# Wisconsin Department of Transportation

**Proposal #12: 1300-03-72, WISC 2021 140**  
**Lake Parkway – Milwaukee / St Francis**  
**E Lincoln Ave to S. Pennsylvania Ave**  
**STH 794**  
**Milwaukee County**

This is Addendum No. 04, which provides for the following:

**ADDENDUM NO. 04**

Addendum No. 04  
 ID 1300-03-72  
 Revised Sheet 383  
 February 3, 2021

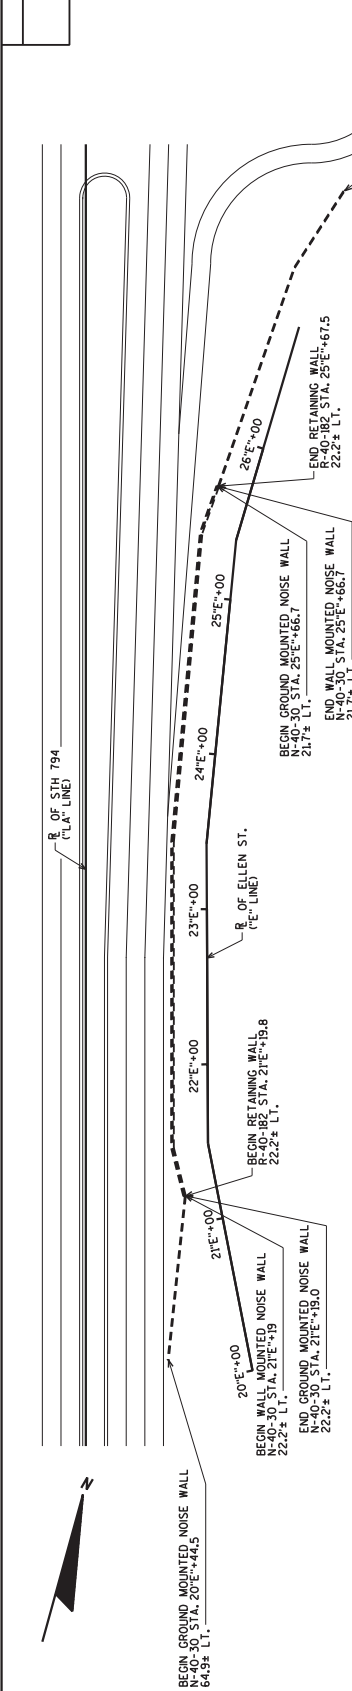
<b>Revised Plan Sheets</b>	
<b>Plan Sheet</b>	<b>Plan Sheet Title (brief description of changes to sheet)</b>
383	General Plan Structure N-40-29 (Panel removal item change)
384	General Plan Structure N-40-30 (Panel removal item change)
385	General Plan Structure N-40-31 (Panel removal item change)
386	General Plan Structure N-40-32 (Panel removal item change)

1. LOCATE SOUND PANELS THAT HAVE SETTLED PAST THE EXISTING SUPPORT BRACKETS.
2. REMOVE AND SALVAGE EXISTING SETTLED SOUND PANELS OUT FROM THE STRUCTURAL SUPPORT POSTS BY LIFTING THEM OUT, COST TO REMOVE, STORE, AND REINSTALL THE SOUND PANELS IS INCLUDED IN THE BID ITEM "REMOVING OLD STRUCTURE 574-14-44-95-RT". ANY DAMAGE TO THE SOUND PANELS CAUSED BY THE CONTRACTOR SHALL BE INCIDENTAL TO THE CONTRACTOR'S COST FOR REPAIRING DAMAGED SOUND PANELS.
3. REPAIR OLD STRUCTURE 574-14-44-95-RT, "REMOVING AND REINSTALLING SOUND PANELS".
4. FIELD PAINT REPAIRED SOUND BARRIER PANEL SUPPORT BRACKETS AS SHOWN IN THE DETAILS.
5. CLEAN RUSTED AREAS OF STRUCTURAL SUPPORT POSTS TO BARE METAL AND APPLY PRIMER AND INTERMEDIATE COATS TO THE AREAS.
6. OVERCOAT PAINT ALL THE STRUCTURAL SUPPORT POSTS AND BRACKETS. PAINT SHALL BE BROWN, AMS STANDARD COLOR NO. 20059.
7. REINSTALL SALVAGED SOUND PANELS.

BID ITEM NUMBER	BID ITEMS	UNIT	TOTAL
574-14-44-95-RT	REMOVING OLD STRUCTURE 574-14-44-95-RT	LS	1
574-14-44-95-RT	STRUCTURE OVERCOATING CLEANING AND PRIMING N-40-29	LS	1
SPV.0060.01	PRECAST SOUND BARRIER PANEL SUPPORT REPAIR	EACH	20
SPV.0060.02	REMOVING AND REINSTALLING SOUND PANELS	EACH	75
